Public Works (1897) Department.

Inspection Notes by the Acting Chief Engineer
on the Ootacamund Lake Reclamation,
Recaded.

Inspection Notes
of
Acting Chief Engineer

Oct. 13, 15, 16, 18, 19.
Ootacamund Lake Reclamation.

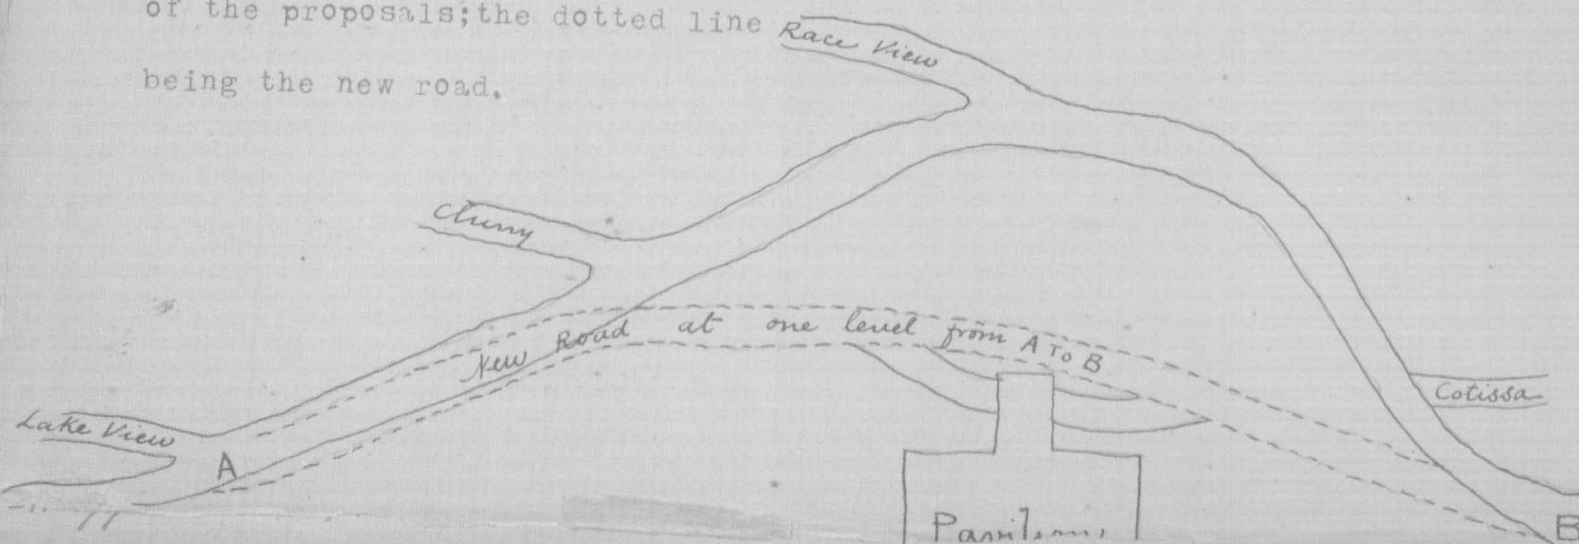
1. The scarp of the new road from Lake view to the site of the new Pavilion is too steep for its --- height, and, with water percolating underneath, it will cause much -- trouble to maintain if left as it is: also there is an awkward drop from the summit of the road to the level of the pavilion. I have ascertained from levels taken by the -- supervisor, that an absolutely level road can be obtained for a length of 1025 feet, starting from near the entrance to Lake view on east, passing just in front (south) of the proposed pavilion, and joining the new road below Cotissa on west. The level of this road will be at the level of Pavilion upper floor, and its construction will serve 2 purposes.

The objections to it are that
 (a) The road already made will have to be destroyed for a length of about 400 feet.

(b) Residents at Cluny etc. and Race View will be cut off from access to the A B C ground and the east by the present route and will have to go round via Cotissa and the pavilion.

(1) It will reduce the height of the scarp above mentioned by from $\frac{1}{3}$ to $\frac{1}{2}$ its height, and thereby make its maintenance much easier.

(2) It will give a much easier approach from both sides to the Pavilion, and be of great benefit to the public.

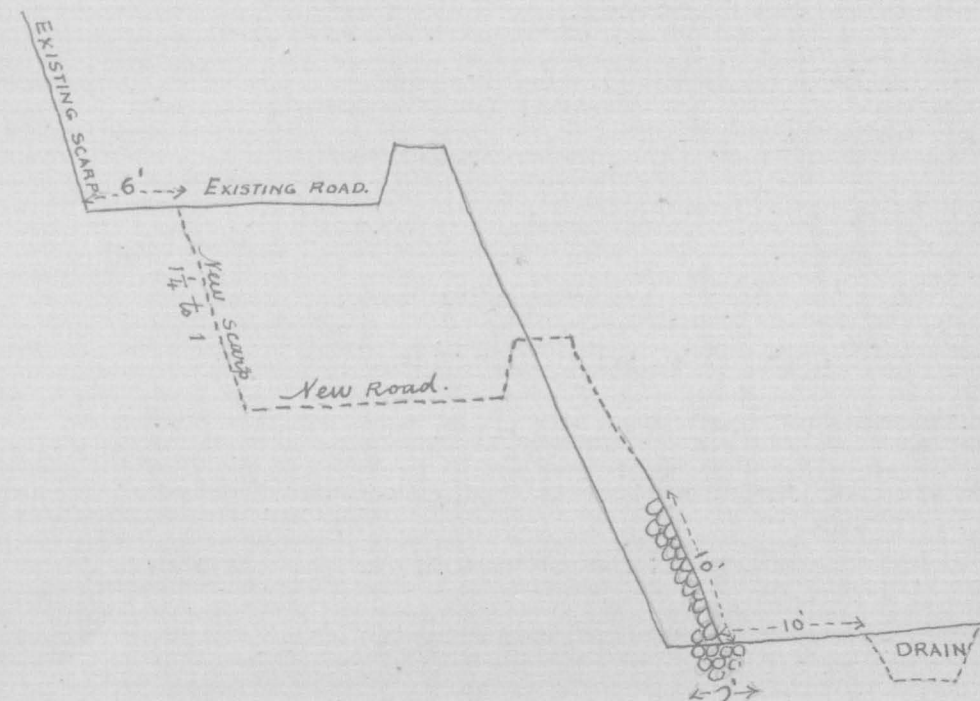
The advantages far outweigh, in my opinion, the disadvantages, and I request that

(1) a new survey may be made as soon as possible showing the proposed new road.

(2) sections may be taken, to show what the additional cost will be, if any.

Both will have to be submitted to Government for orders, and should also be submitted to the Gymkhana Committee for approval as regards the approaches to the Pavilion. The following sketch gives a rough idea of the proposals; the dotted line being the new road.
